BIDDING ADDENDUM NO. [03](#)

JOHNSON CITY CENTRAL SCHOOL DISTRICT

JCCSD CAPITAL PROJECT PHASE 2

HA PN 2024-239P

PLANTER DETAIL

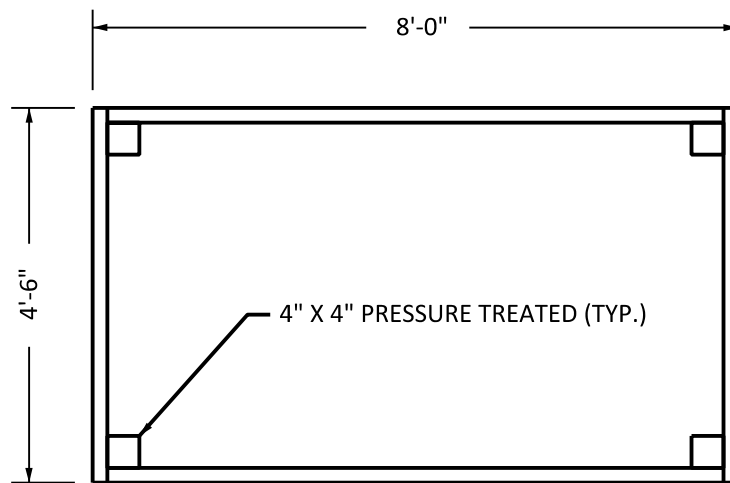
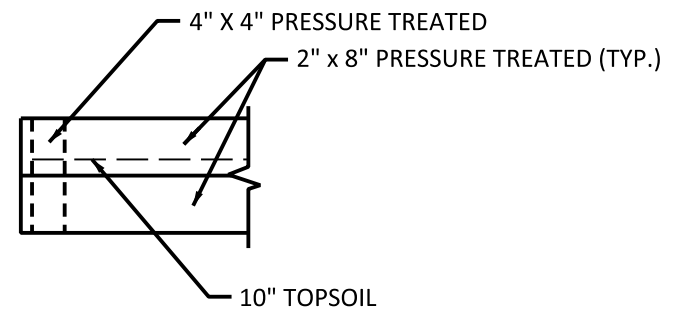
Request: Note 1 on C101 states "planters shall match existing"

CD003 calls out removing and storing planters

Are we relocating the existing planters or furnishing new ones? Dwg. C101 calls to reset planters.

We are now disposing . Are new required by Site Contract? If so can a detail be supplied?

New planters required, detail attached. Remove and dispose of old planters.

DRAWING NO.:
C113

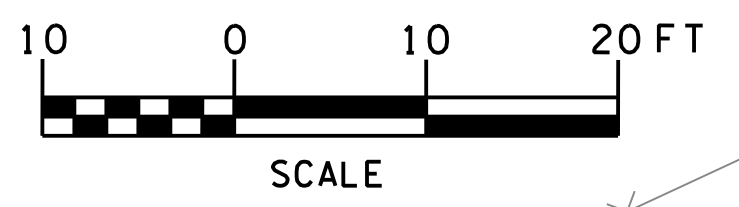
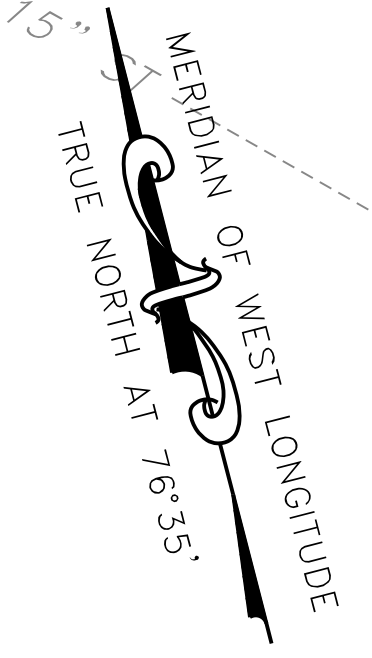
- A. HS C113
1. Designated Light Duty Pavement at K-8

NOTES:
1. SEE ELECTRICAL PLANS FOR LIGHTING LAYOUT AND DETAILS.
2. HEAVY DUTY PAVEMENT RECONSTRUCTION WHERE ELECTRIC CONDUIT CROSSES WILDCAT WAY AND 45 EXIT ROAD. SAWCUT EDGES OF PAVEMENT. SEE ELECTRIC PLANS FOR LOCATIONS.

HS MD-105

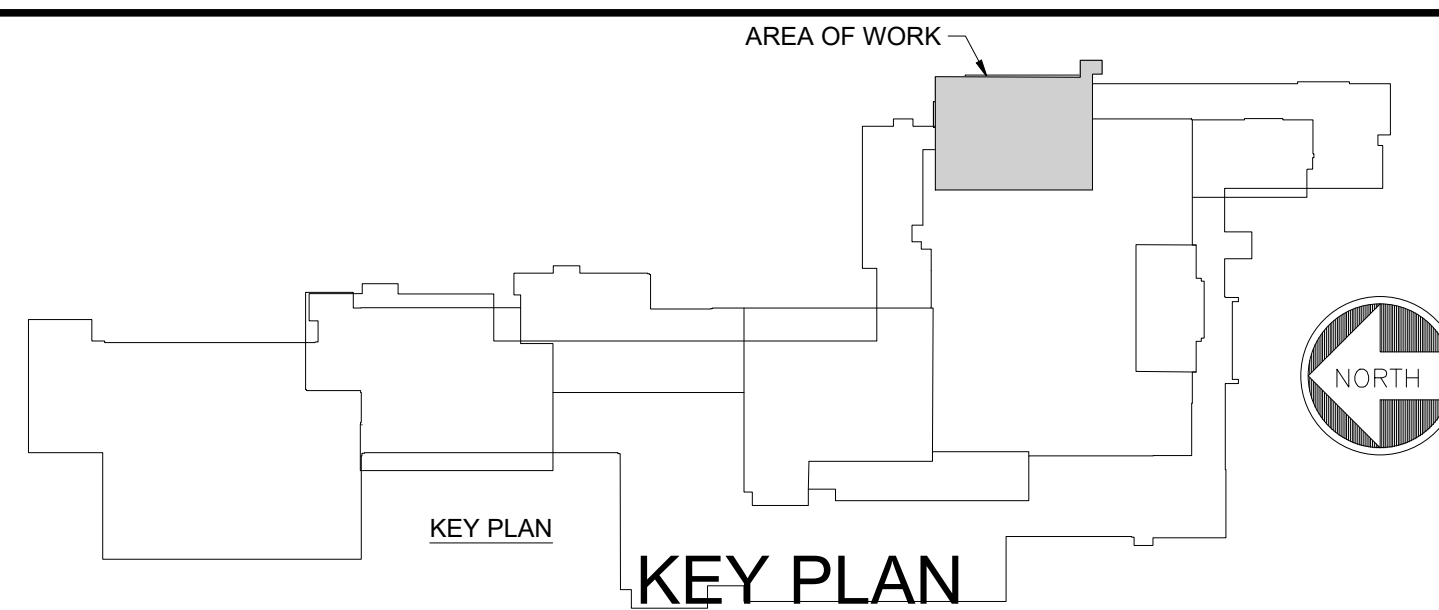
Request: ARE THE RTU'S LABELED RTU 3-5 AND ASSOCIATED
ROOF PENETRATIONS NEW OR EXISTING? THE MECHANICAL SCHEDULE DOES
NOT MENTION THEM. PLEASE CLARIFY IF THESE ARE NEW ROOF
PENETRATIONS.

ANSWER: There is (1) new roof penetration. The other (7) penetrations are existing to remain. See attached SKETCH M-113 with markings. That 20"x20" duct penetration is being moved to accommodate the new addition and allow better access to the low roof. See attached roof patching markings on MD-105.

- EXISTING ROOFTOP UNIT TO REMAIN.
- EXISTING ROOFTOP DUCTWORK TO REMAIN TO EXTENT SHOWN.
- REMOVE EXISTING ROOFTOP UNIT AND ROOF CURB. TEMPORARILY PROTECT THE OPENING IN THE ROOF FROM LEAKING WATER/NOISE/ETC. INTO BUILDING. PREPARE ROOFING FOR NEW UNIT CURB. ROOF SHALL BE PATCHED TO MATCH SURROUNDING SURFACES. DO NOT VOID THE ROOF WARRANTY.
